Introduction

The AVR128DB28/32/48/64 devices you have received conform functionally to the current device data sheet (www.microchip.com/DS40002247), except for the anomalies described in this document. The errata described in this document will likely be addressed in future revisions of the AVR128DB28/32/48/64 devices.

3. Data Sheet Clarifications

40.4.4 BOD

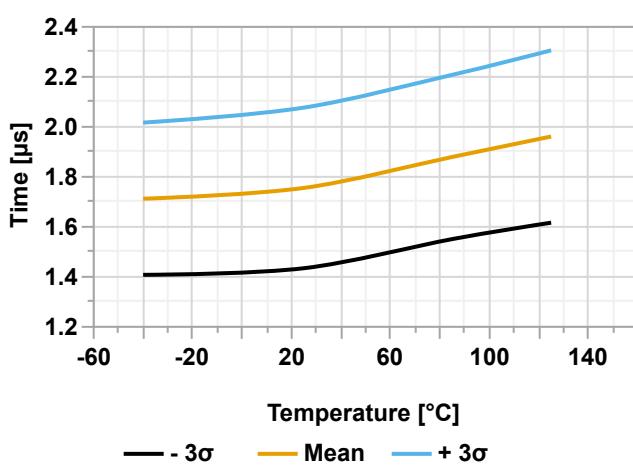
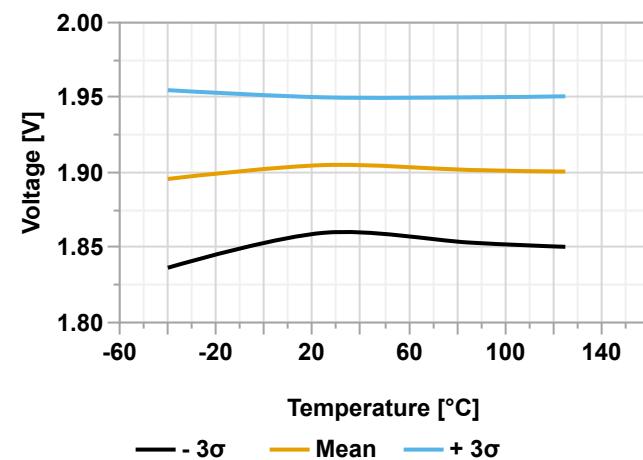
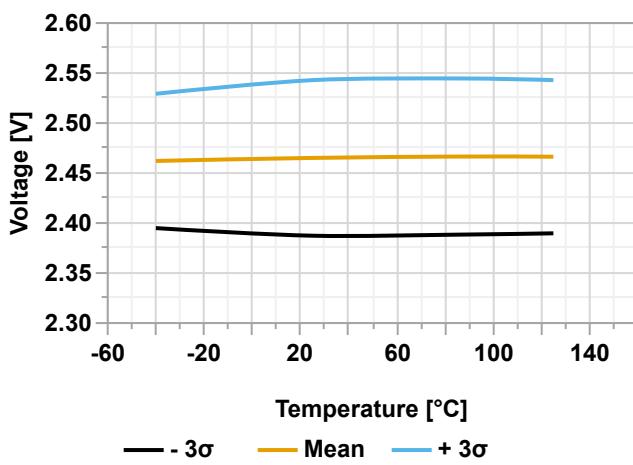
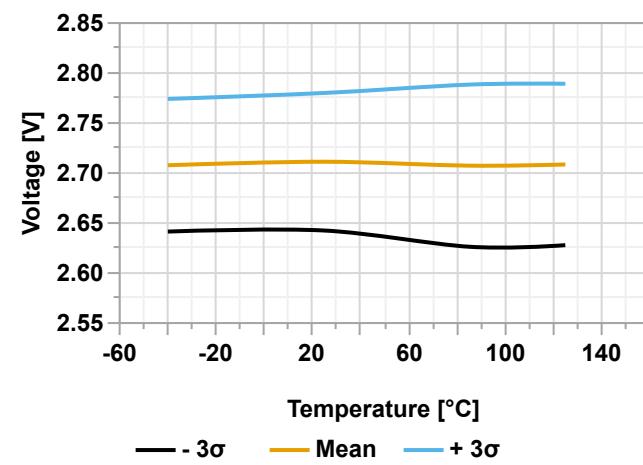
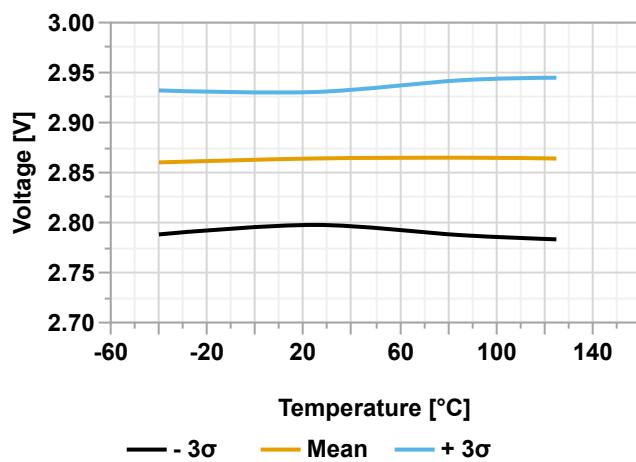
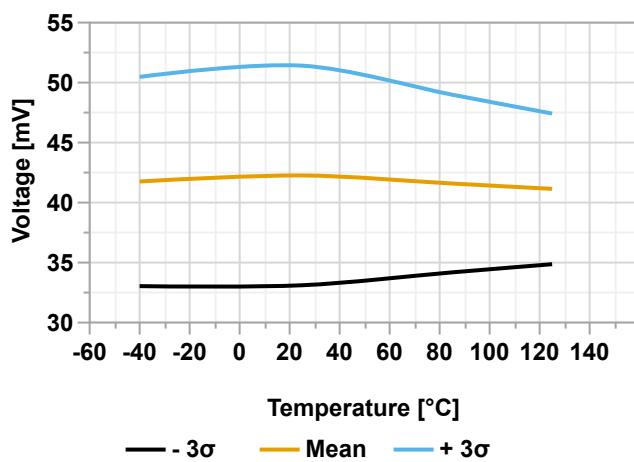
A clarification was made to the *BOD* section in *Characteristics Graphs*.

One plot has been removed: **Figure 40-51. BOD Response Time vs. Temperature**. As a result, the *BOD* section of the *Characteristics Graphs* section now is reduced from 13 to 12 plots and look like the following.
